Access Audit Final Site Report

**Old Orchard Country Club
700 W Rand Rd
Mt Prospect, IL 60056**

**Inspection Date: 02/28/2024
Inspectors: Shelley Zuniga**

Prepared By
WT Group

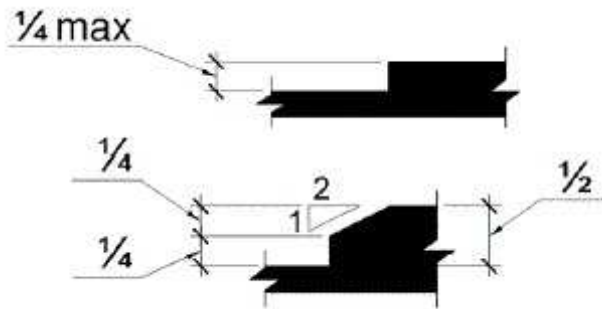
2018 IAC Section: 502.4

2010 ADAS Section: 502.4

Acquire or replace and mount at appropriate heights and locations accessible parking signs where incorrect or missing. We recommend R7-8 signage.

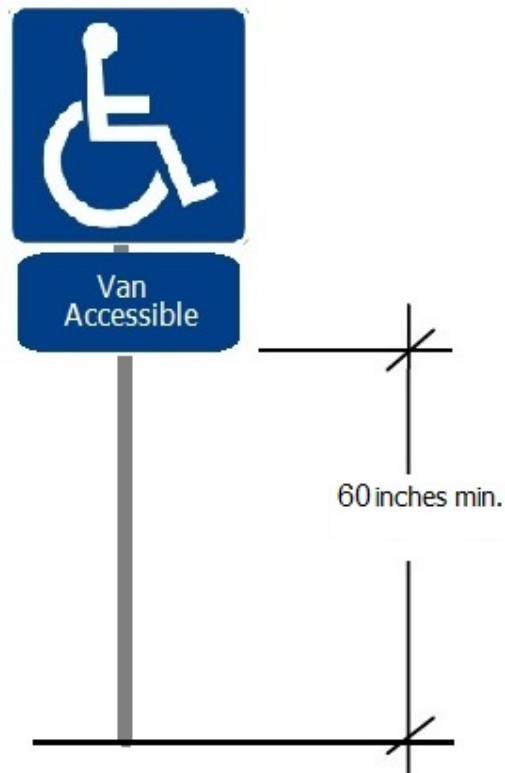
2018 IAC Section: 502.6

2010 ADAS Section: 502.6

Add one van parking sign to one accessible stall and assure stall and access aisle to 11' and 5' or 8' and 8'.

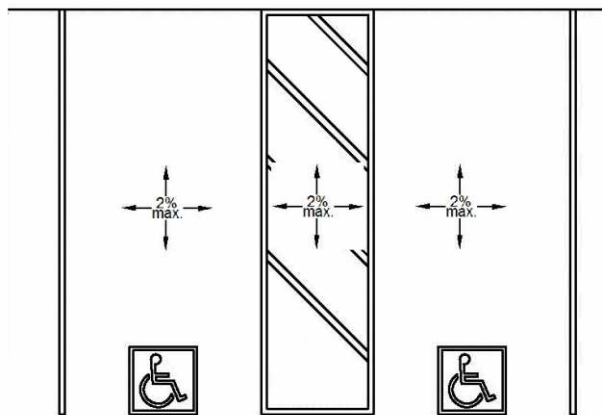
2018 IAC Section: 502.4, 502.4 Exception

2010 ADAS Section: 502.4

Assure correct slope of parking space and access aisle to max 2.08% in any direction on newly relocated stalls.

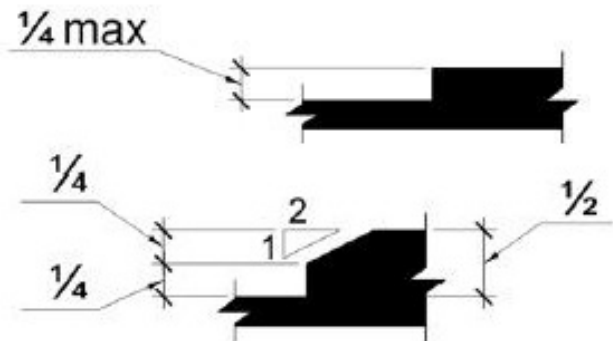
2018 IAC Section: 303.2, 303.3

2010 ADAS Section: 303.2, 303.3

Repair, bevel or ramp change in level along accessible route.

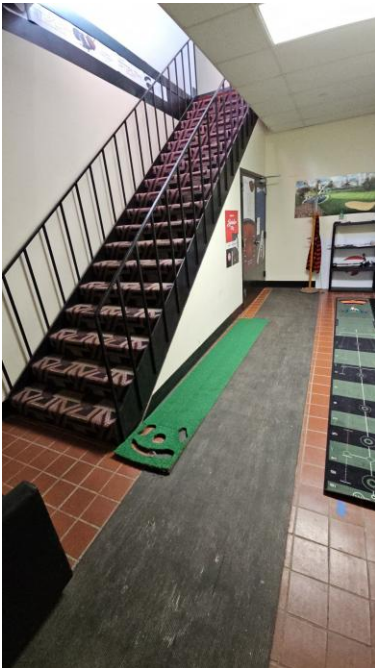
2018 IAC Section: 206.2.4

2010 ADAS Section: 206.2.4

Provide vertical access to all levels of the building.

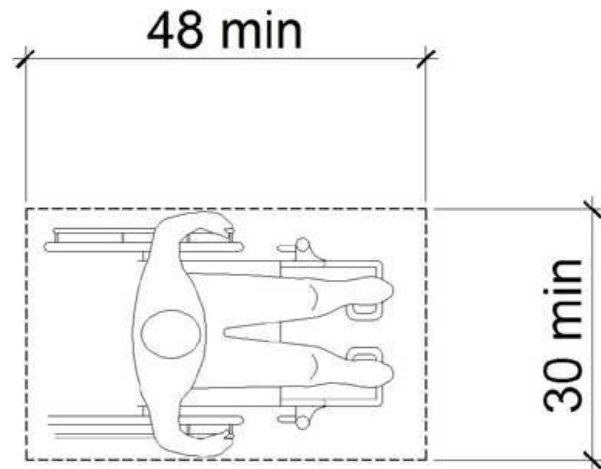
2018 IAC Section: 305.3

2010 ADAS Section: 305.3

Remove, or relocate storage in CFS at fixtures and operable parts.

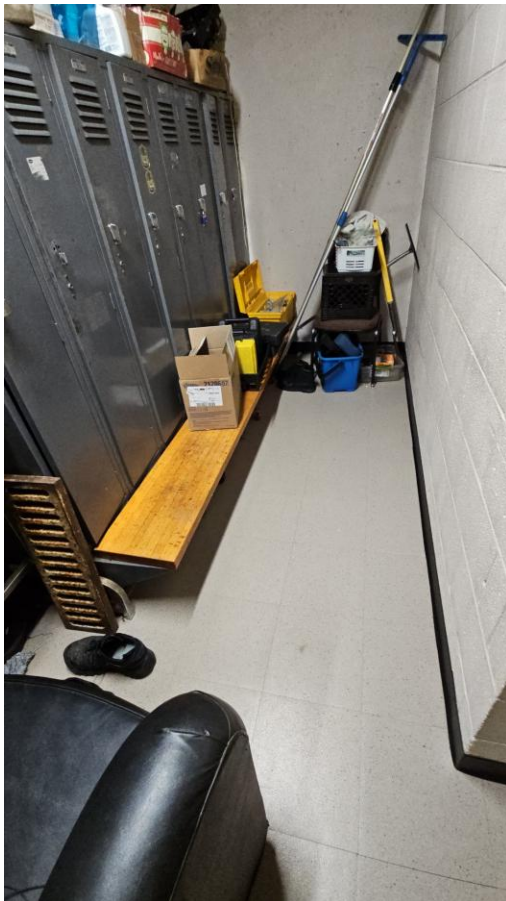
2018 IAC Section: 305.3, 811.2

2010 ADAS Section: 305.3, 811.2

Provide required 30" by 48" CFS at designated accessible lockers.

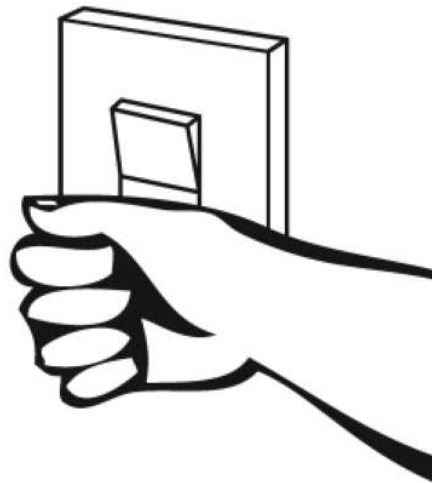
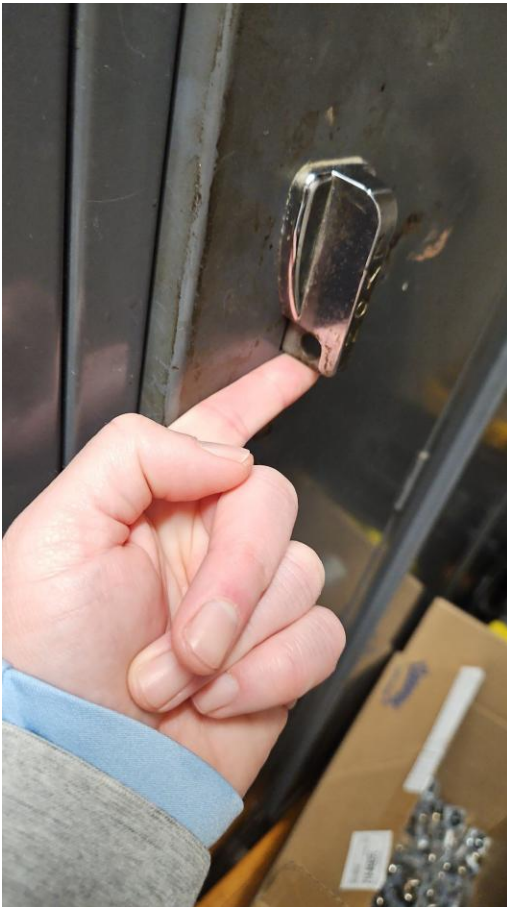
2018 IAC Section: 309.4

2010 ADAS Section: 309.4

Replace operable part with one usable without a tight pinch or grasp on newly designated locker.

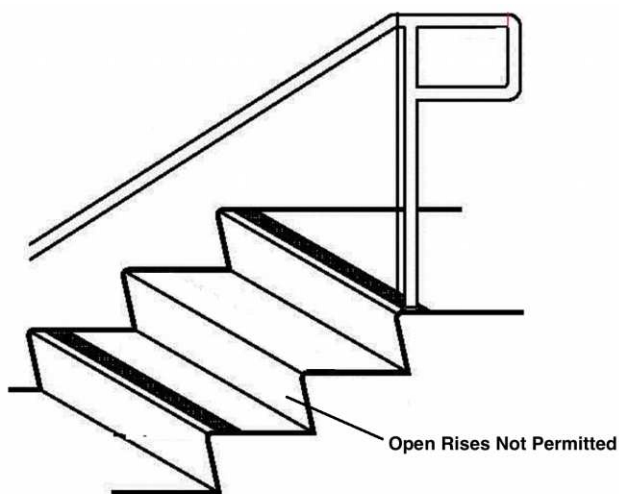
2018 IAC Section: 504.3

2010 ADAS Section: 504.3

Install kick plates on all stairs or replace with ones having closed risers

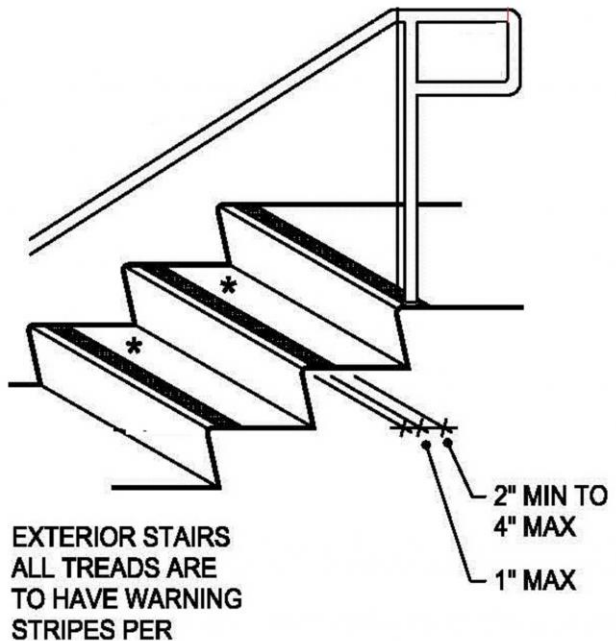
Stairs from upper kitchen to basement kitchen - 17 treads lack visual contrast

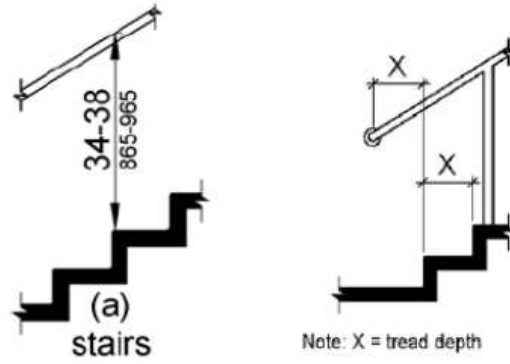
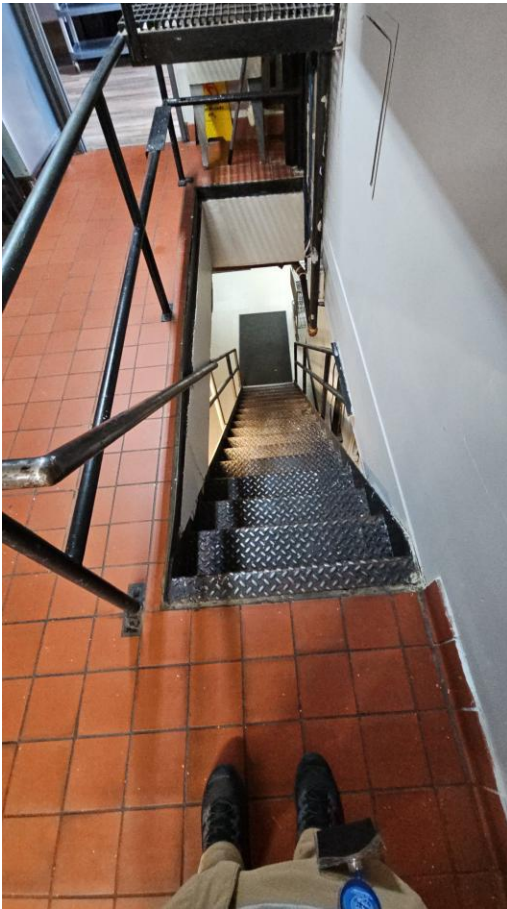
Stairs from upper kitchen to basement kitchen -Partial handrail on one side

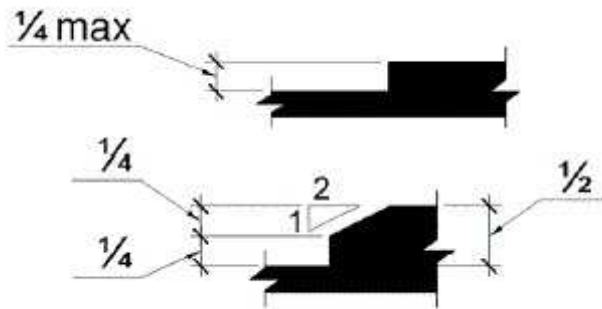
There is a change in level greater than 1/4 inch.

2018 IAC Section: 303.3

Provide a temporary ramp for access to stage upon request.

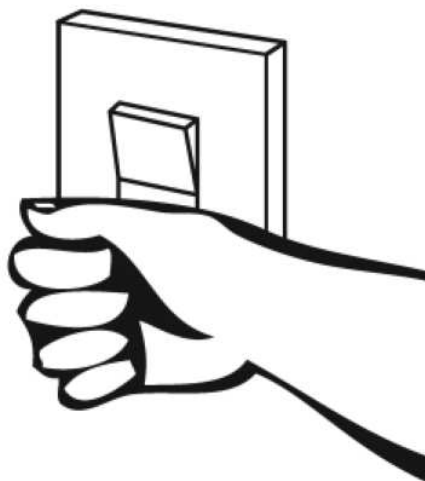
2018 IAC Section: 309.4

2010 ADAS Section: 309.4

Replace operable part with one usable without a tight pinch or grasp.

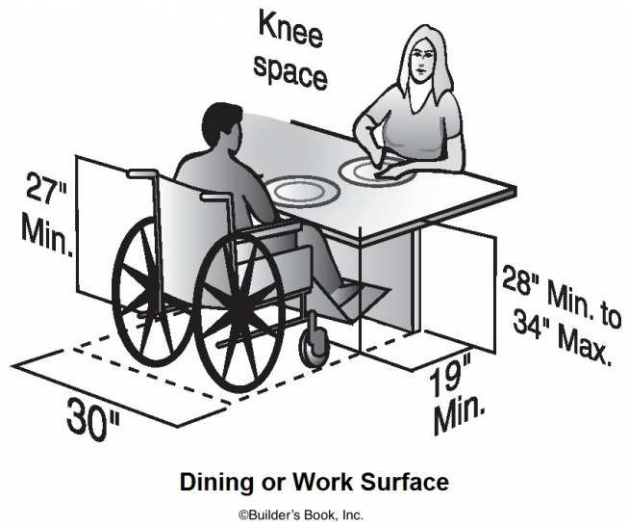
2018 IAC Section: 902.3

2010 ADAS Section: 902.3

Lower a 36" wide portion of bar counter, or provide table service for bar items.

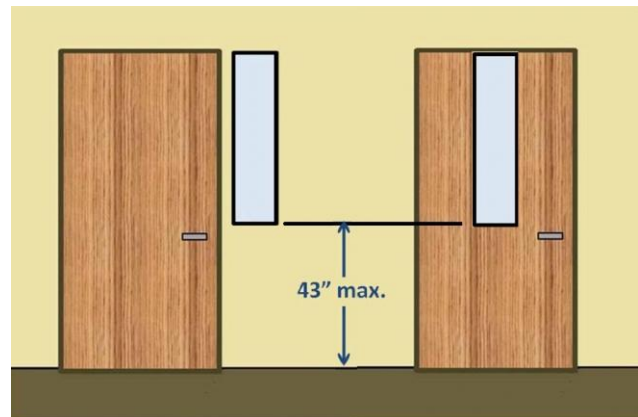
2018 IAC Section: 404.2.11

2010 ADAS Section: 404.2.11

Replace doors with ones having sidelight viewing windows max 43" AFF.

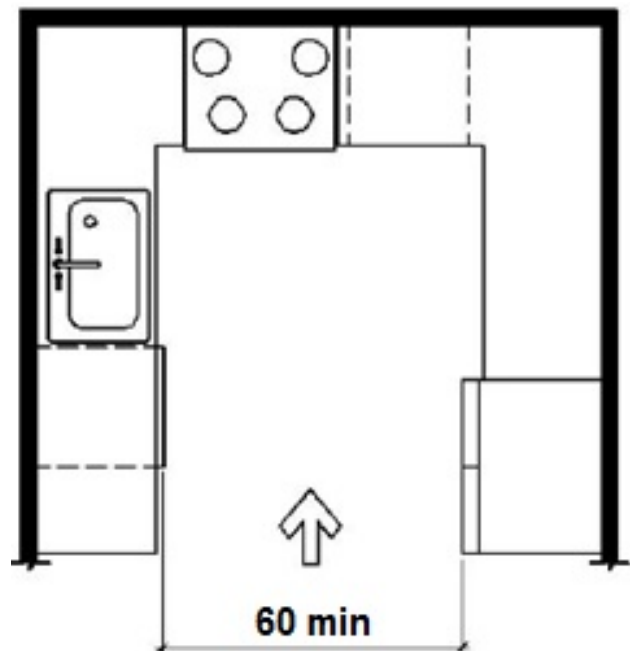
2018 IAC Section: 804.2.2

2010 ADAS Section: 804.2.2

Rearrange prep area to provide 60" clearance between appliances and cabinets.

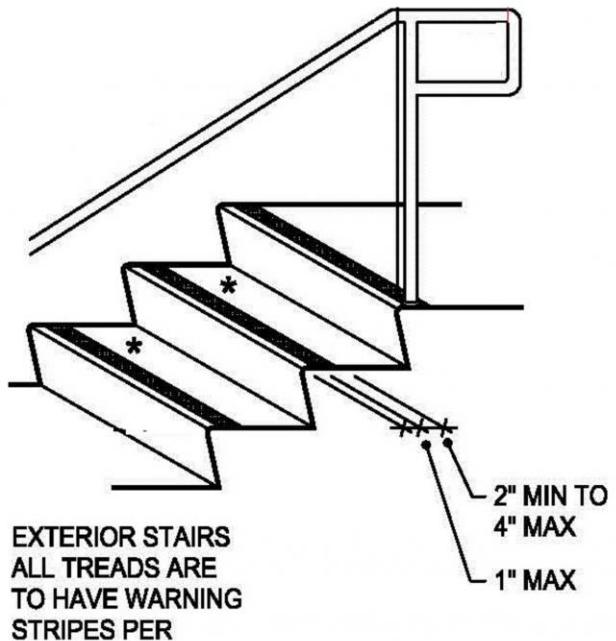
Stairs to basement
putting practice area -
18 of 19 treads lack
visual contrast

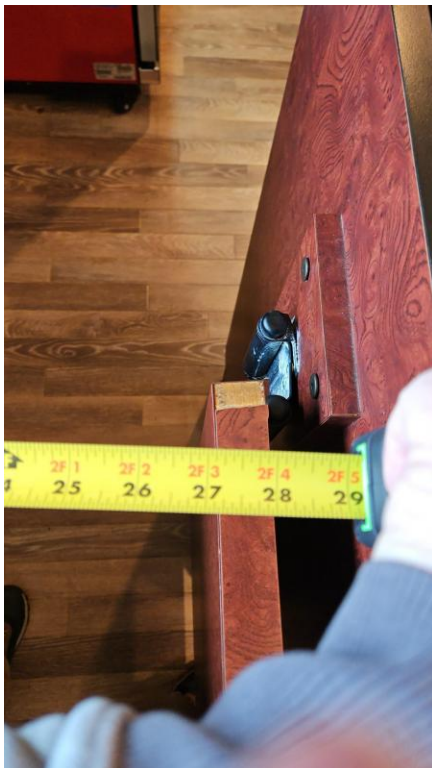
behind counter - swing
door entry only 27.25"
wide

For employee spaces, relocate storage, furniture, and other obstacles at doorways to provide approach, enter and exit at the employee space.

Replace doors with doors having 80" overhead clearance and 32" clear width.

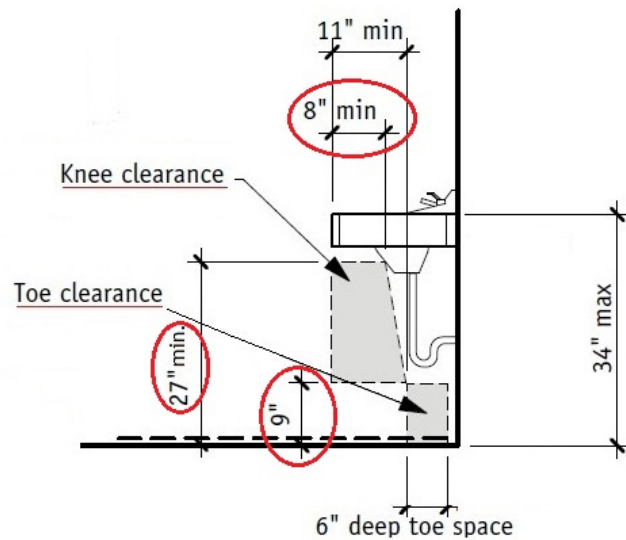
2018 IAC Section: 306.3.1, 306.3.2, 306.3.3, 306.3.4, 306.3.5

2010 ADAS Section: 306.3.3, 306.3.2, 306.3.4, 306.3.5, 306.3.1

Remove cabinet at one sink for knee clearance.

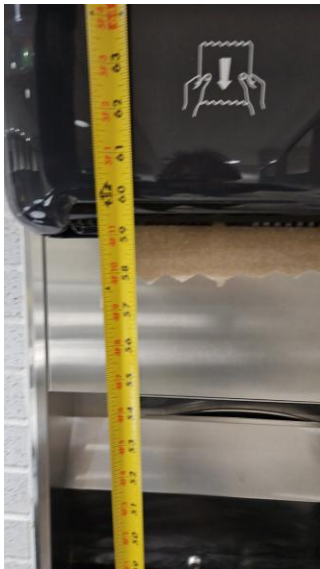
paper towels at 58"
and 54" over sink,
hook in stall at 62"

Create a wheelchair accessible stall with grab bars and fixtures mounted in correct locations and at correct heights.

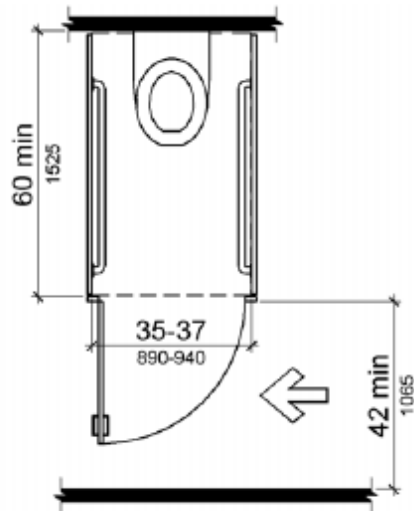
2018 IAC Section: 604.8.2.1

2010 ADAS Section: 604.8.2.1

Correct ambulatory stall to be 35" to 37" wide and minimum 60" deep; or in the alternative, use existing ambulatory stall to create wheelchair stall if feasible.

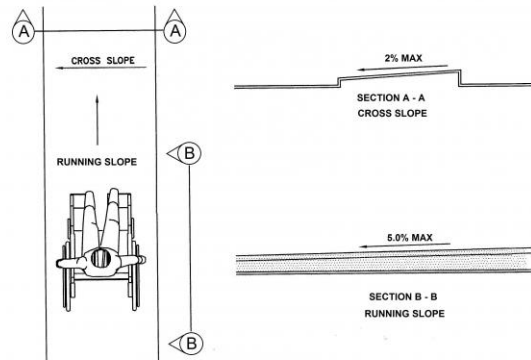
2018 IAC Section: 403.3

2010 ADAS Section: 403.3

Correct or repair slope to max 2.08% in restroom.

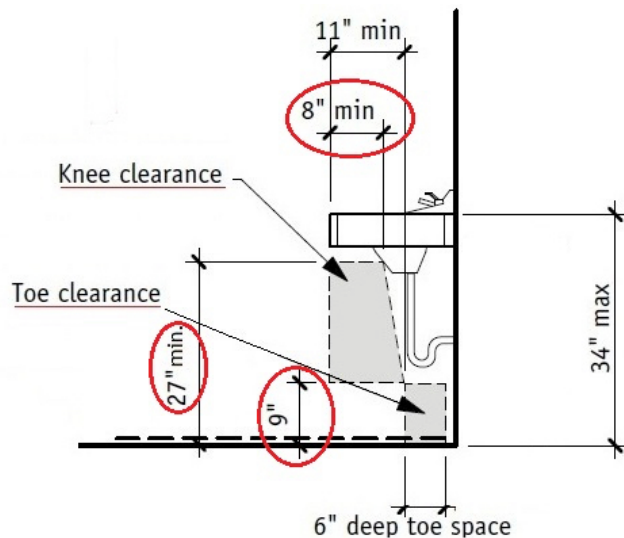
2018 IAC Section: 306.3.1, 306.3.2, 306.3.3, 306.3.4, 306.3.5

2010 ADAS Section: 306.3.3, 306.3.2, 306.3.4, 306.3.5, 306.3.1

Relocate garbage bin for clearance at sink. Remove cabinet for knee clearance.

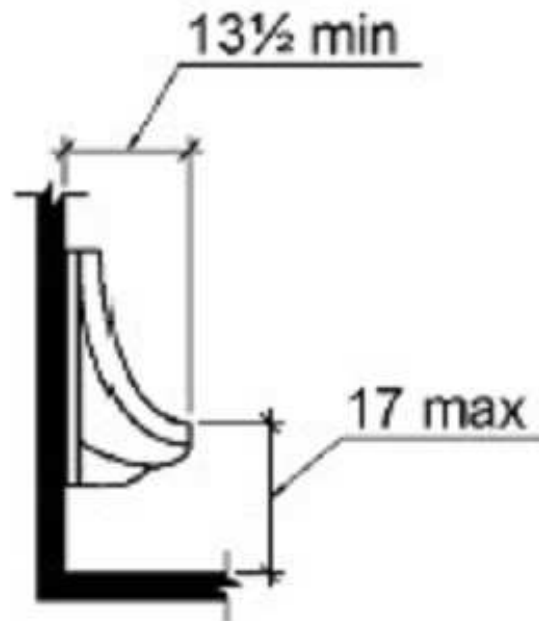
2018 IAC Section: 605.2

2010 ADAS Section: 605.2

Replace urinal with one having a 13.5" min depth mounted at max 17" to rim with flush controls max 48" AFF.

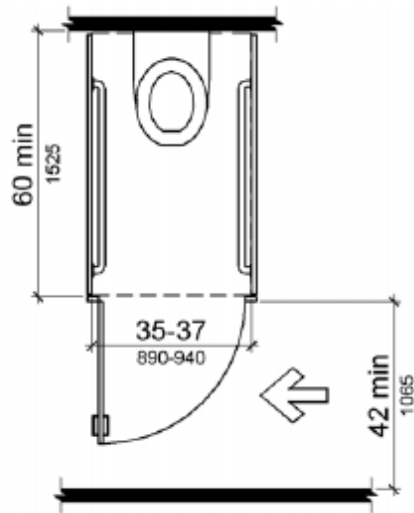
2018 IAC Section: 604.8.2.1

2010 ADAS Section: 604.8.2.1

Correct ambulatory stall to be 35" to 37" wide and minimum 60" deep or use existing stall to create required wheelchair stall.

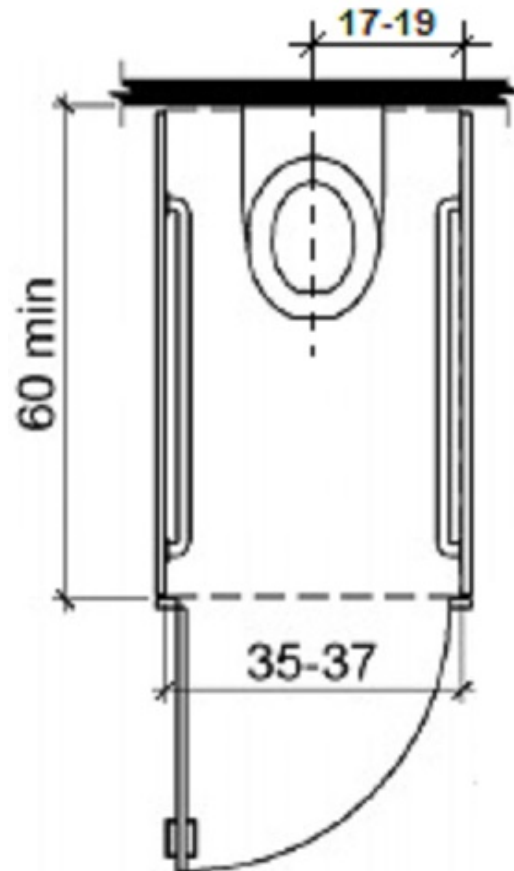
2018 IAC Section: 604.9.1

2010 ADAS Section: 604.9.1

Replace stall hardware with hardware operable without a tight pinch or grasp on both sides of the stall door.

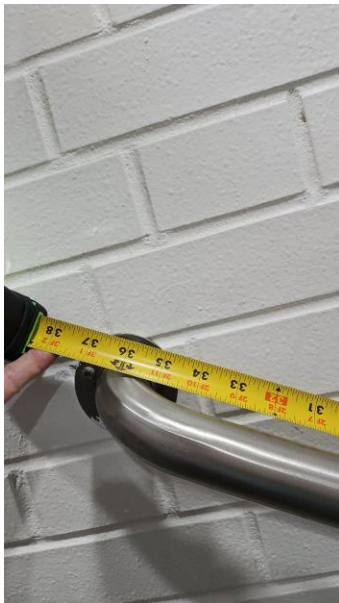
2018 IAC Section: 604.8.2.3, 609.3, 609.4

2010 ADAS Section: 609.3, 609.4, 604.8.2.3

Add grab bars for the appropriate stall - two side bars for ambulatory, or a side and rear for the new wheelchair stall. Side bars shall be a 42" long grab bar, mounted max 12" from the rear wall at the close end and min 54" on the far end and 33" to 36" aff. Rear bar shall be 36" long and mounted 12" to the closed side and 24" to the open side of the toilet measured from the centerline.

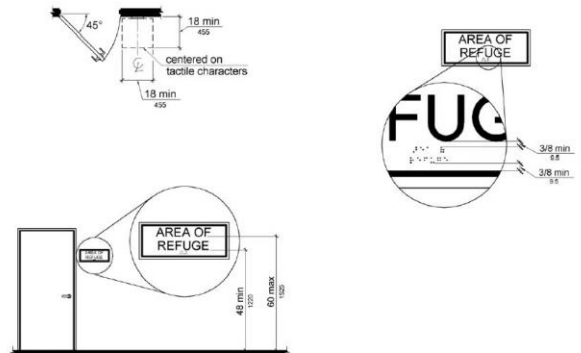
2018 IAC Section: 216.2, 703.1, 703.2, 703.5, 703.6

2010 ADAS Section: 216.2, 703.1, 703.2, 703.5, 703.6

Replace sign with one of contrasting colors that includes Braille, raised characters, and the symbol of accessibility and mount on the wall, latch side of the door, 48" to the baseline of the lowest character and 60" to the baseline of the highest character.

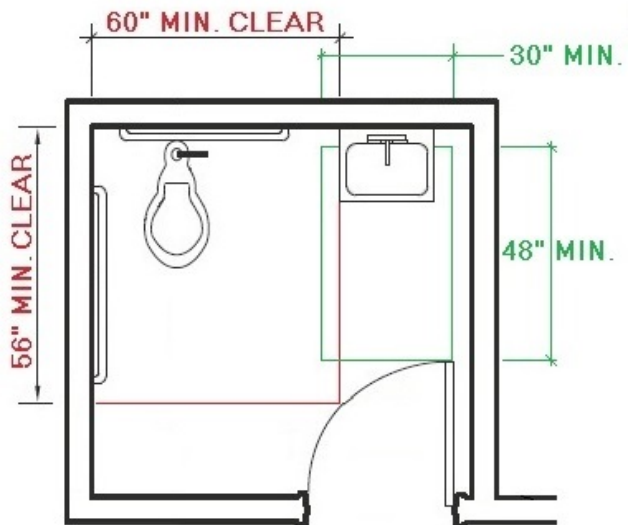
2018 IAC Section: 603.1

2010 ADAS Section: 603.1

Create a compliant wheelchair accessible restroom and correct all features to be accessible if feasible.

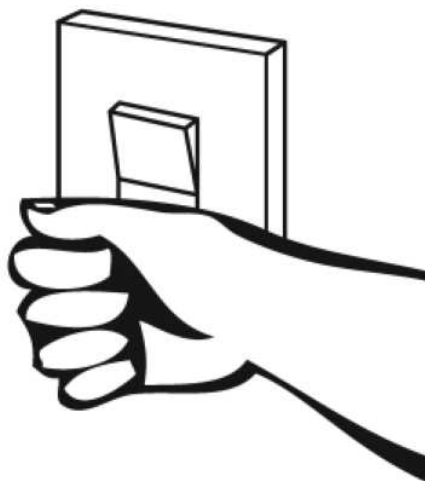
2018 IAC Section: 309.4

2010 ADAS Section: 309.4

Replace operable part with one usable without a tight pinch or grasp.

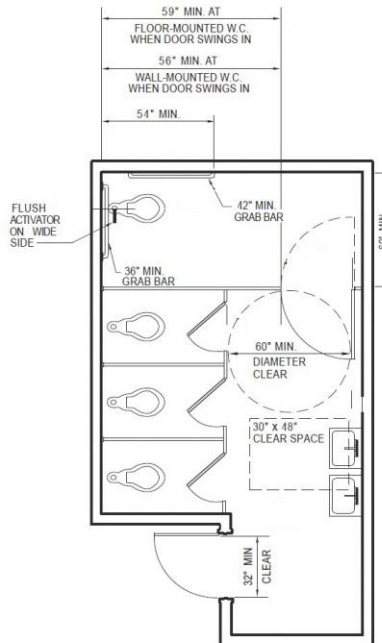
- The restroom does not have the required minimum clear floor space or maneuvering clearances for the toilet.
- The restroom does not have the required minimum clear floor space or maneuvering clearances for the lavatory.
- The entry door does not contain the required minimum 60 inches maneuvering space on the pull side
- The entry door encroach into the required clear floor space for fixtures.
- Door opening pressure was measured at greater than 5 pounds.
- Grab bars are incorrectly installed.
- Accessories, such as toilet seat covers, paper towel holders, garbage cans, hand dryers and mirrors are either too high or without clear floor space or both.
- The restroom contain floor level changes greater than a 1/2 inch at the floor drains.

Create a compliant wheelchair accessible stall in restroom and correct all features to be accessible
